5th and Virginia

SECTION 02. DRB REC1 GUIDANCE AND DESIGN RESPONSE

SECTION 02. DRB REC1 GUIDANCE & DESIGN RESPONSE

West Elevation Hotel Levels 3 - 11

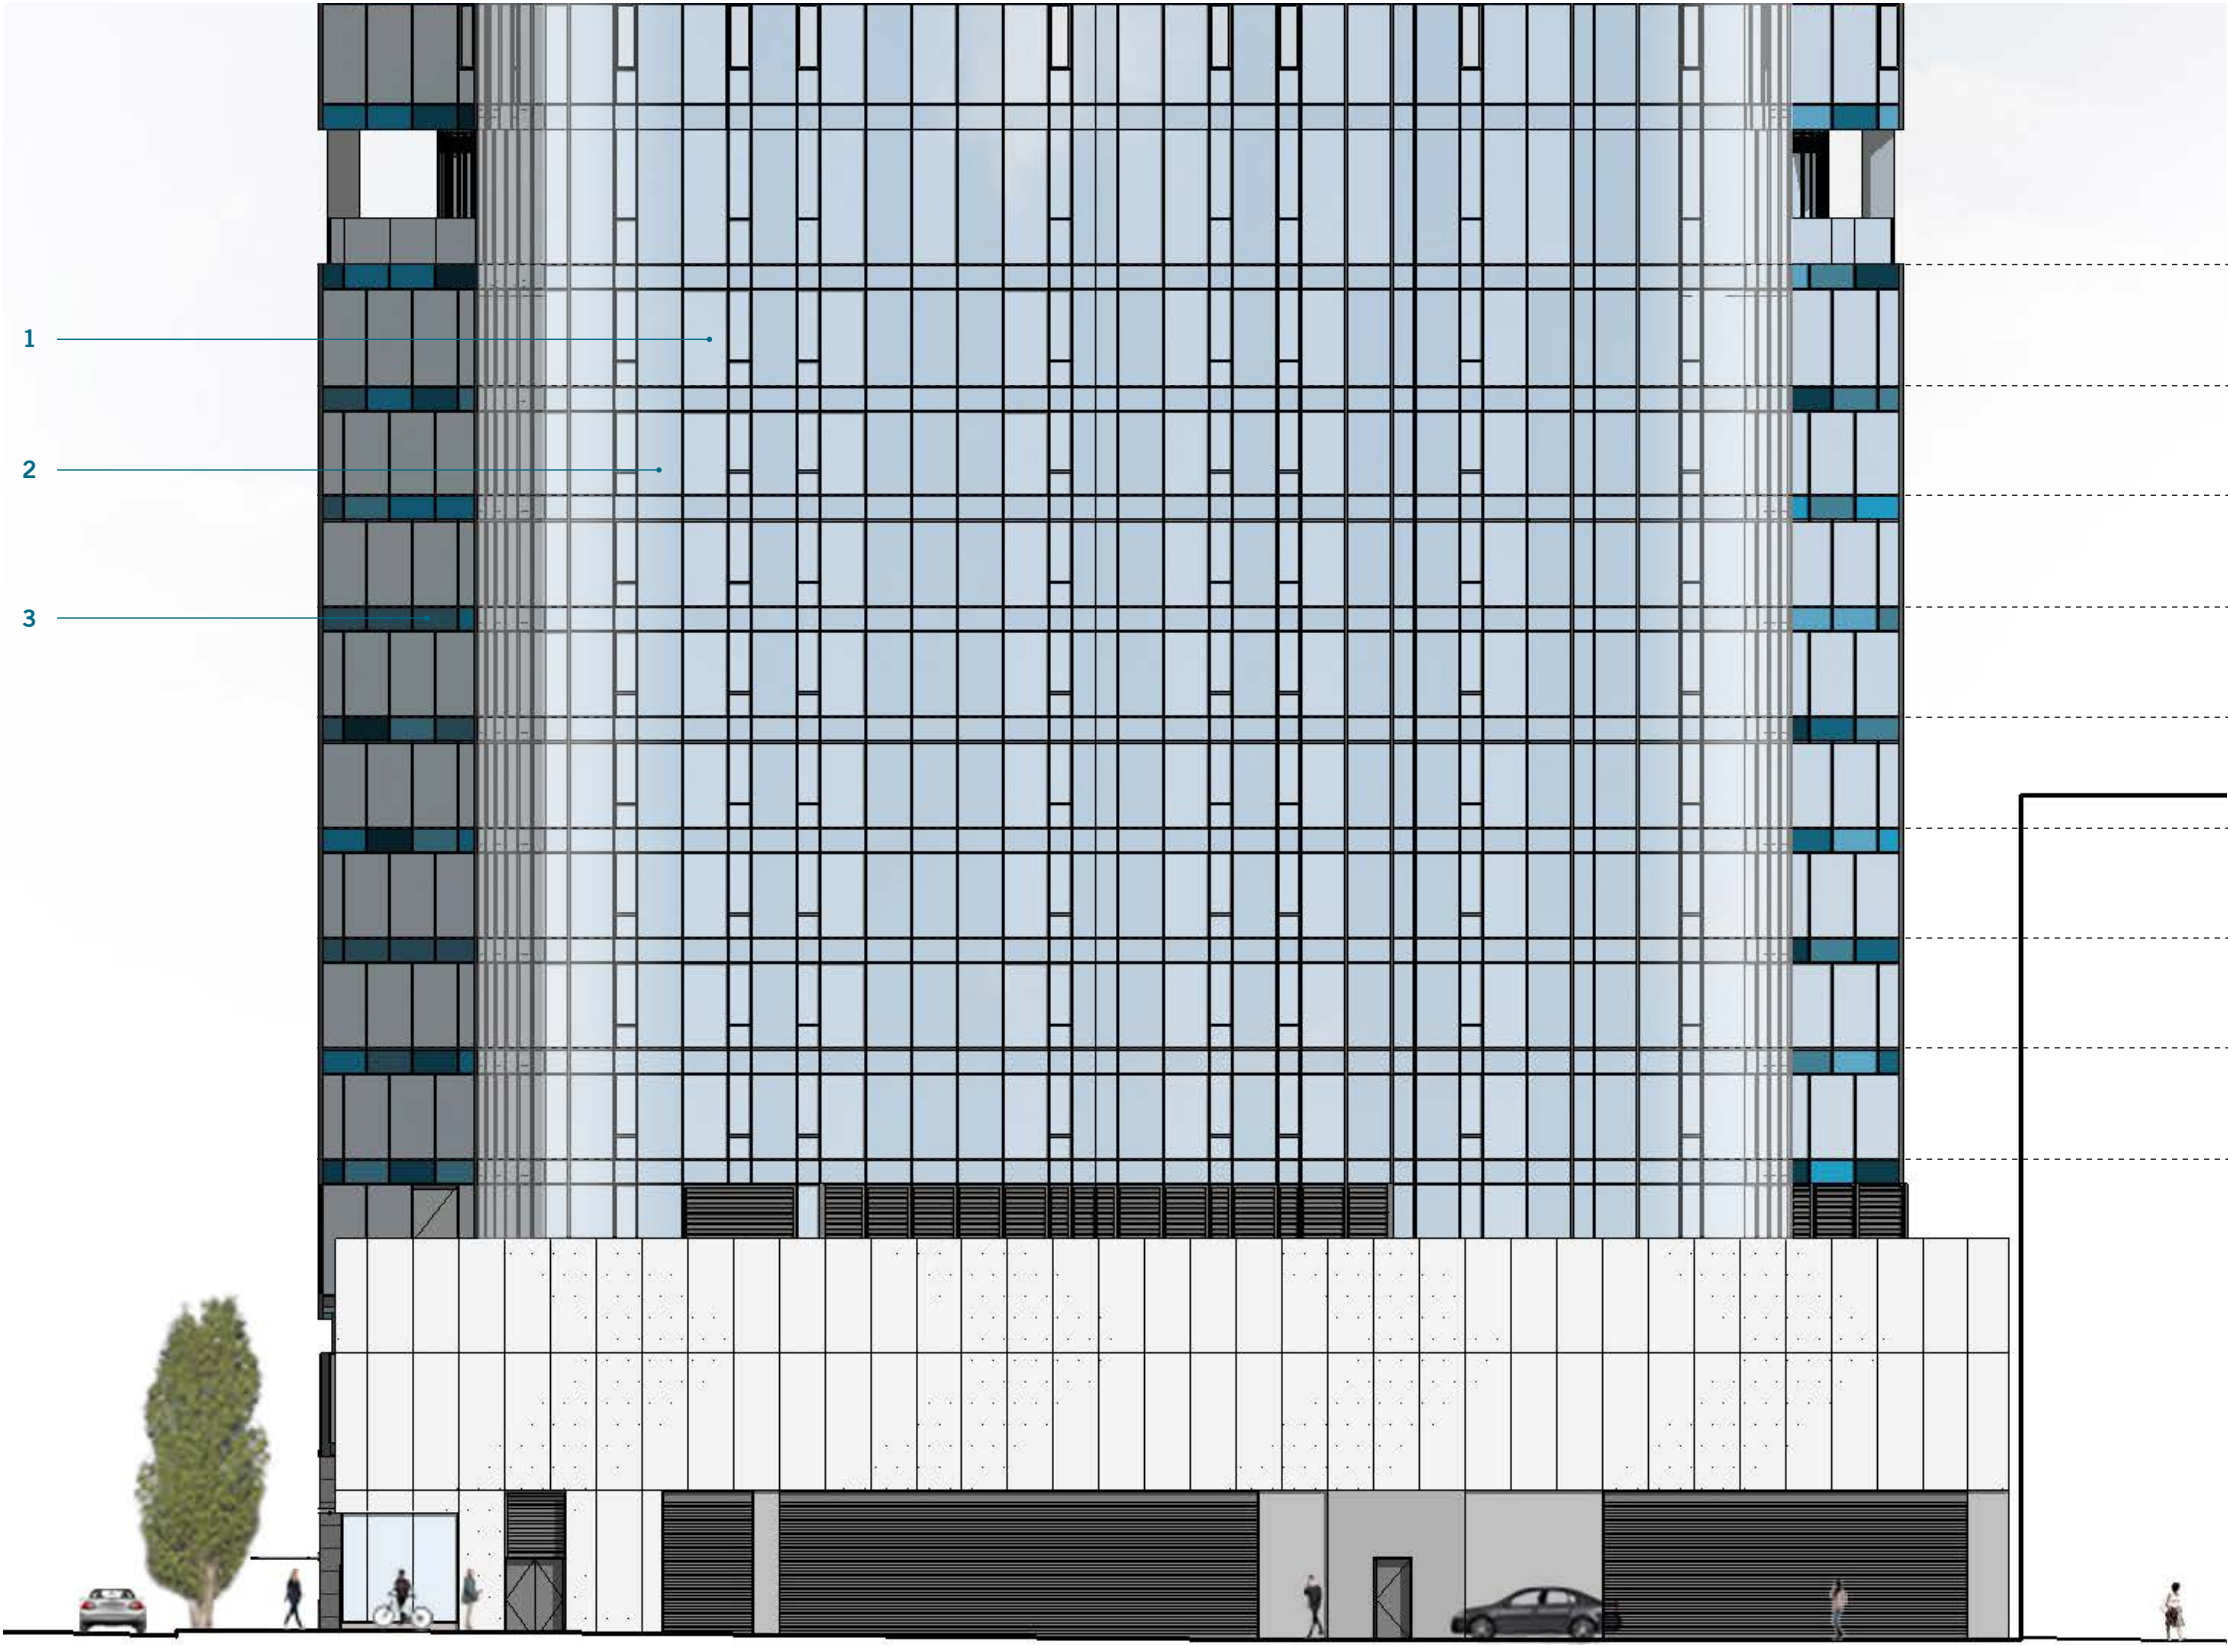
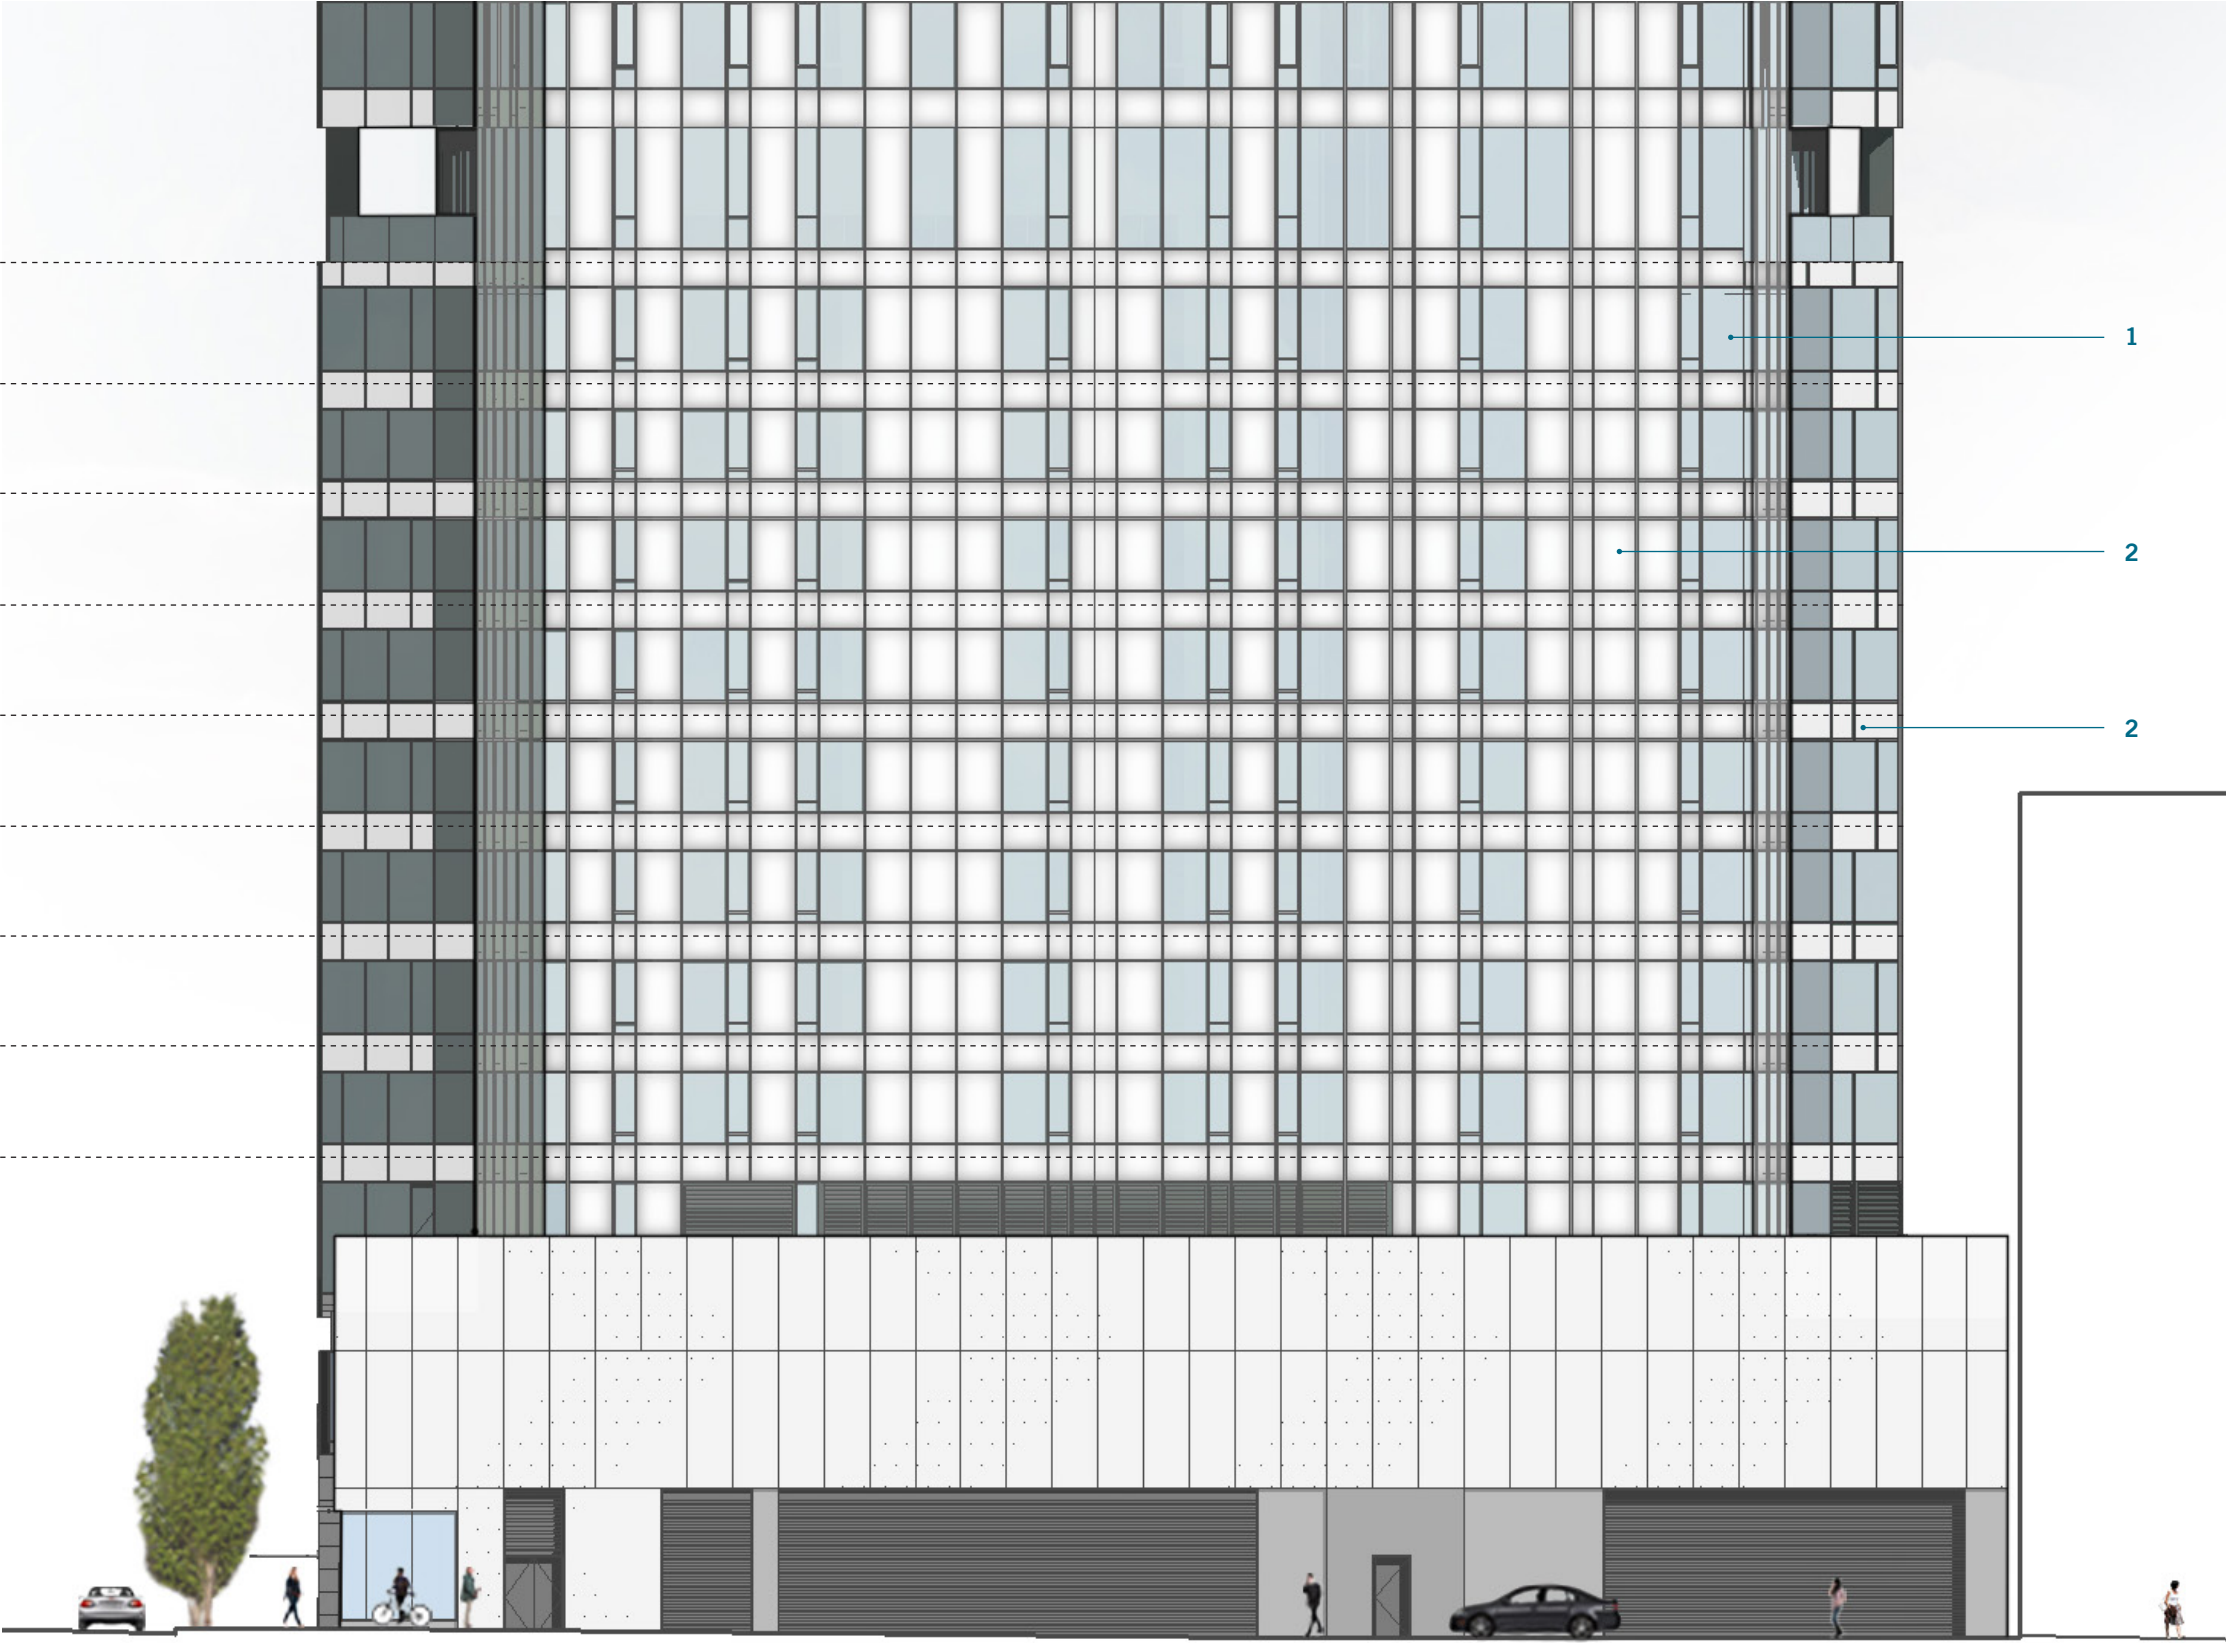
Comparison of sill heights at hotel (levels 3-11) illustrating reduction in vision glass.
